Support bracket for X85 drive units Type H

Technical bulletin from FlexLink

5393EN-1

Support bracket for drive unit

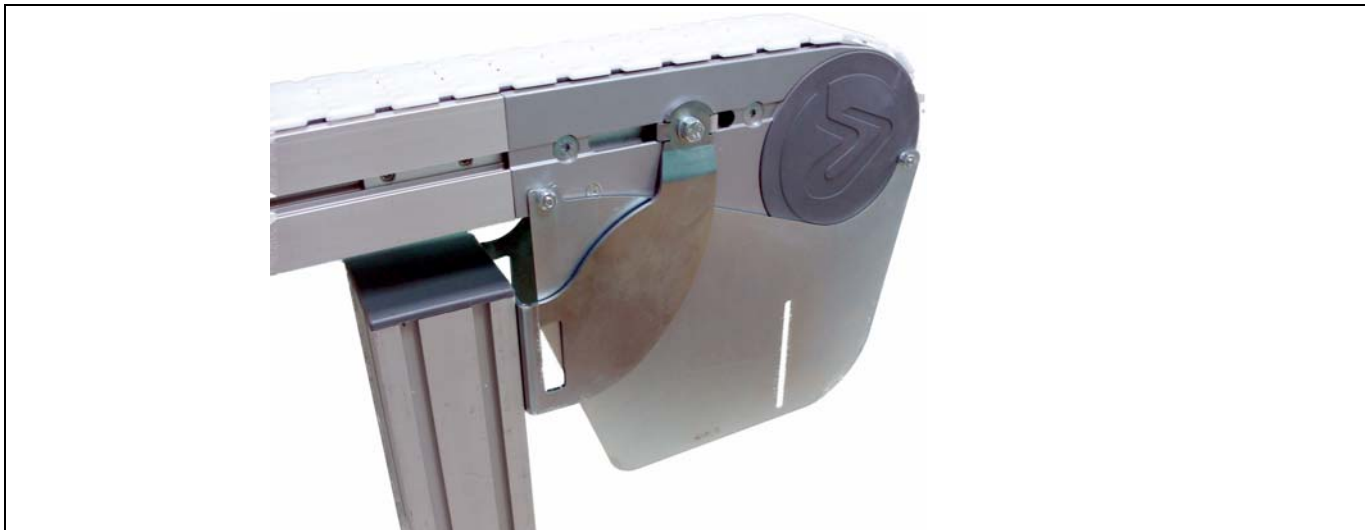
New bracket uses drive unit's T-slot for firm support

A new type of support bracket uses the T-slot of the direct drive units. This results in a rigid support at the drive unit, instead of just supporting the conveyor beam next to the drive unit. The new support is primarily intended for X85 direct drive unit Type H without slip clutch.

The recommended support solution for direct drive units with slip clutch is to connect the support beam to the adapter plate.
